**MEMORANDUM DATE:** September 8, 2021

**RE:** **518 South L Street**

**TITLE:** **HRPB Project Number 21-00100076:** Consideration of a Certificate of Appropriateness (COA) for window replacement for the property located at **518 South L Street**; PCN #38-43-44-21-15-167-0070. The subject property is a contributing resource to the Southeast Lucerne Local Historic District and is located in the Single-Family Residential (SF-R) zoning district.

**Staff Recommended Options**

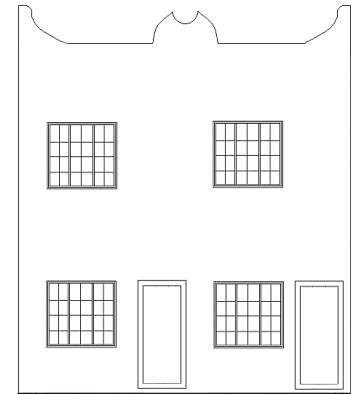
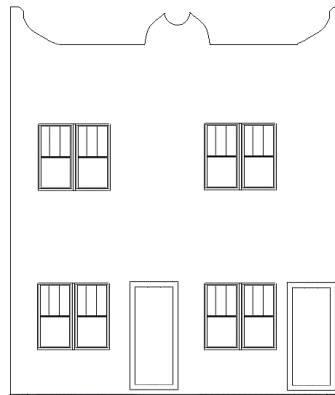
Administratively, staff could approve single-hung windows with or without decorative light patterns on the top sash for the majority of windows. The front façade features horizontally-oriented single-hung windows that are atypical for Mission Revival structures. Staff recommends that the four (4) windows on the front façade match the north and south elevation’s configuration of paired openings separated by a mullion. Alternatively, a triplet of casement windows or horizontal rollers (equal thirds configuration) with decorative light patterns could be replicated as this was a common configuration for Mission Revival structures, depicted on the next page:

Utilizes paired single-hung windows separated by a mullion or a triplet of casement windows/horizontal rollers (equal thirds configuration)

As discussed in the property development history, the openings on the front façade received approval in 2001. Therefore, these openings can be replaced in-kind by the property owner although it is not the *most successful* approach to replicating original windows in a Mission Revival structure.

**Staff Analysis:** Overall, full-view single-hung windows for every opening are an approvable option at permitting with the exception of the grey tinted Low-E coating. However, greater compatibility could be achieved by utilizing single-hung windows with or without decorative light patterns on the top sash for the majority of windows. In addition, the front façade could match the north and south elevation’s configuration of paired openings separated by a mullion. Alternatively, a triplet of casement windows could be replicated as this was a common configuration for Mission Revival structures.
